Technical Service Bulletin

22-01-090H

PALISADE (LX2)

DRIVER'S SIDE WIPER ARM REPLACEMENT
(RECALL CAMPAIGN 233)

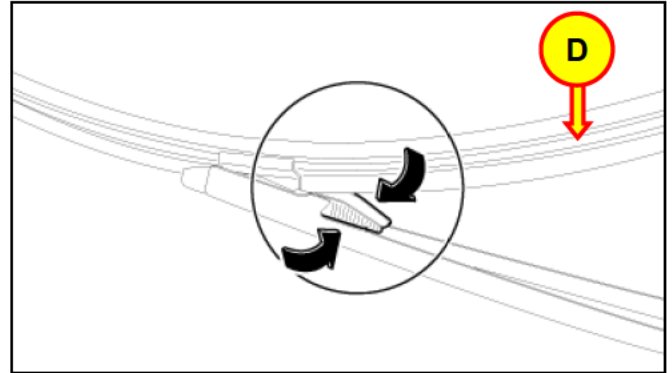
2. Remove the driver's side wiper arm plug (B) and the wiper arm nut (C).

Tightening Torque:

16.6 – 19.5 lb-ft (22.6 – 26.5 Nm)

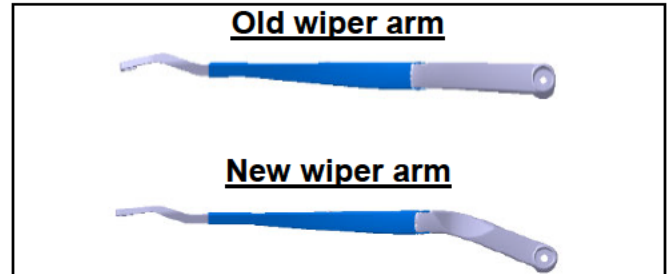
3. Remove the wiper arm from the vehicle and remove the existing wiper blade (D) by pressing the wiper blade clip as shown.

4. Install the existing wiper blade onto the new wiper arm.

- Ensure the wiper blade is firmly attached before installing the new wiper arm. If the wiper blade is missing or improperly installed, the new wiper arm may cause damage to the windshield.

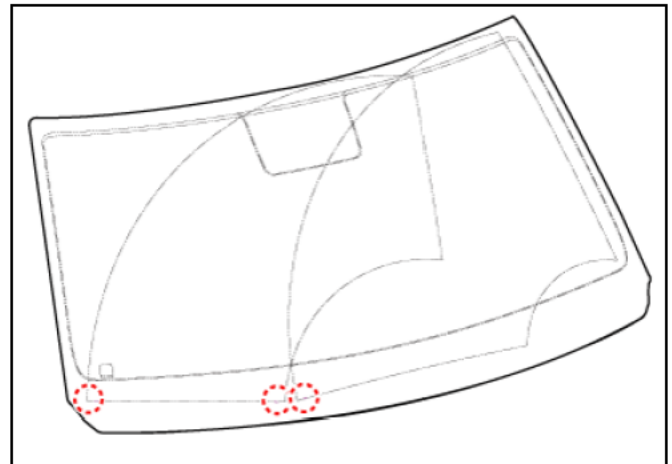
5. Reinstall all parts in the reverse order of removal.

- Ensure the driver's side wiper arm and wiper blade are reinstalled in the proper auto stop position.
